Access Compliance Report Public Rights-of-Way (Curb Ramps)

Main Street: FAUNA_DR		Cross Street: FAUNA_DR		Location:	S
ADA ID: RPRK211124123529	Ramp Type: Type 6 - Directional 1	Initial Pass/Fail: Fail	Overall Compliance: No	Severity Score:	16

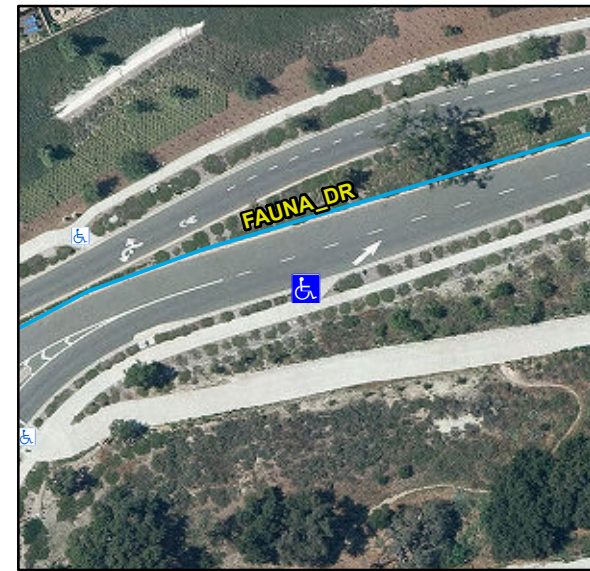
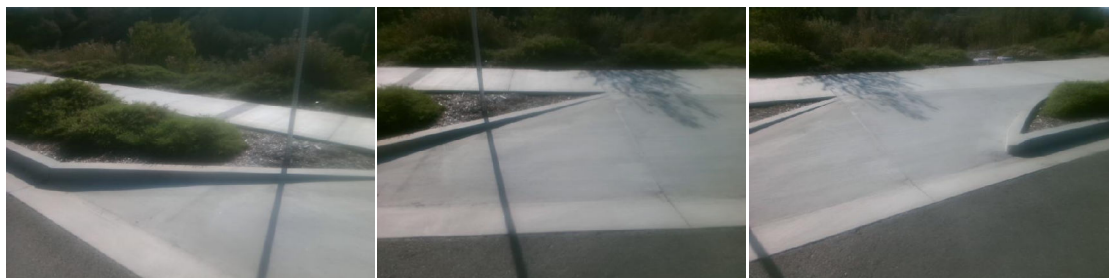
R204.3, R304.2.2, R304.5.3, STD 1115

Compliance	Description	Data	Compliance	Description	Data
N/A	Ramp Length (in)	104	N/A	Flare Type LT	
Yes	Ramp Width (in)	208			N/A
No	Ramp Run Slope (%)	9.5	N/A	Flare Slope LT (%)	N/A
No	Ramp Cross Slope (%)	2.4	N/A	Flare Traversable LT	N/A
N/A	Grade Break	N/A	N/A	Flare Type RT	
N/A	Grade Break Slope (%)	N/A			N/A
N/A	Grade Break Cross Slope (%)	N/A	N/A	Flare Slope RT (%)	N/A
	Addl Para Ramp Left?	No	N/A	Flare Traversable RT	N/A
	Addl Para Ramp Right?	No	N/A	DWS Provided	N/A
N/A	Landing Present	N/A	N/A	DWS Contrast	N/A
N/A	Landing Length (in)	N/A	N/A	DWS Length (in)	N/A
N/A	Landing Width (in)	N/A	N/A	DWS Full Width	N/A
N/A	Landing Run Slope (%)	N/A		DWS Offset Type	N/A
N/A	Landing Cross Slope (%)	N/A	N/A	DWS Left Offset (in)	N/A
N/A	Landing Movement Obstructed?	N/A	N/A	DWS Right Offset (in)	N/A
	Landing Movement Type	N/A			
N/A	Landing Shared	N/A			
N/A	Marked Crosswalk 1	No	N/A	Clear Space	N/A
	Crossing 1 Direction	NE	N/A	Clear Space To Crosswalk (in)	N/A

Marked Crosswalk 1 Width (in)	N/A			
N/A	Ramp Inside Crosswalk 1	N/A			
	Crossing 1 Slope (%)	1.8			
	Crossing 1 Cross Slope (%)	2.1			
N/A	Gutter Ponding	N/A	N/A	Curb Slope	10.7
Yes	Gutter Lip Height (in)	0		Road Run Slope (%)	N/A
N/A	Gutter Run Slope (%)	N/A		Road Cross Slope (%)	N/A
N/A	Gutter Cross Slope (%)	N/A		Parallel Ramp Side	N/A
Yes	Overall Surface Condition	Acceptable	No	Perp Joint Present	No
	Cross Gutter Present?	No		Spandrel Present?	No
	Replace Cross Gutter?	N/A		Replace Spandrel?	N/A

Remove & Replace Entire Ramp.
